UNITED STATES PATENT AND TRADEMARK OFFICE

10/054,173

Office Action Summary	Application No. 10/054,173	Applicant(s) MALONE ET AL.	
	Examiner Jacob Y. Choi	Art Unit 2875

DETAILED ACTION

Drawings

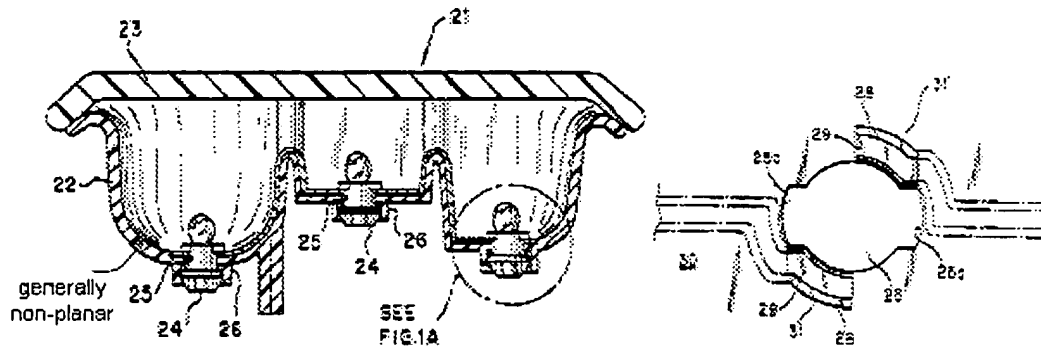
1. Any structural detail that is of sufficient importance to be described should be shown in the drawing (Ex parte Good, 1911 C.D. 43, 164 O.G. 739 (Comm'r Pat. 1911).) See MPEP 608.02. Therefore, applicant needs to show a plurality of compartments, each compartment being generally concave, the conductive material and reflective coating are formed on the substrate within the same vacuum chamber, & the conductive material and reflective coating are formed on the substrate simultaneously in the same vacuum chamber.

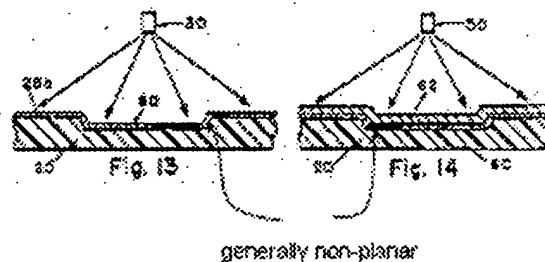
Regarding claims 1, Suzuki et al. discloses the printed circuit board being utilized for a vehicle lamp housing and the conductive material (e.g., 29) is connected to at least one or more light source(s) (e.g., 37) and its power source(s) (e.g., Figures 11-12).

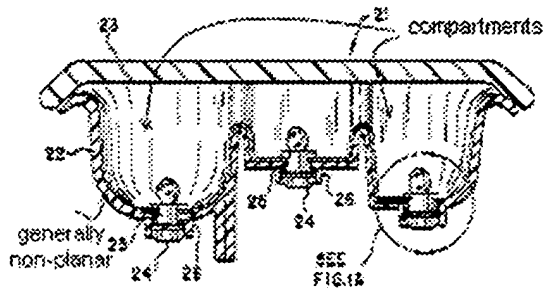
Regarding claim 30, Suzuki et al. in view of Elarde discloses the claimed invention, explained above. In addition, Suzuki et al. disclose the housing comprises one or more smooth corners to facilitate receipt of the conductive layer.

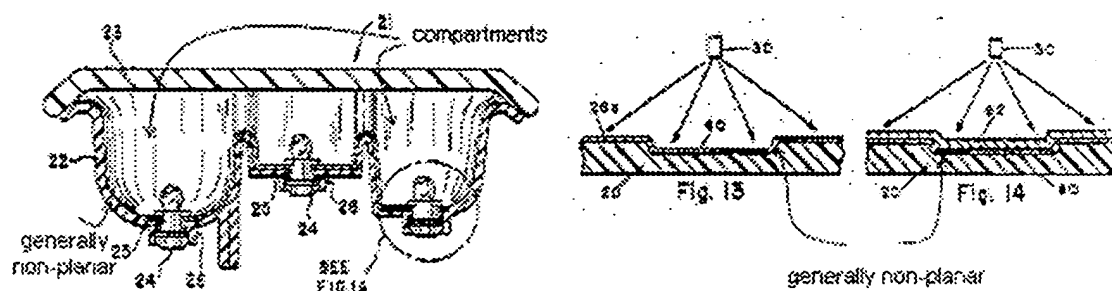
In response to applicant's argument that the references fail to show certain features of applicant's invention, it is noted that the prior art references, Suzuki et al. (USPN 6,290,380) and Elarde (USOPN 4,532,152) clearly shows applying a coating material(s) on a surface that is "generally non-planar" & compartments as indicated below.
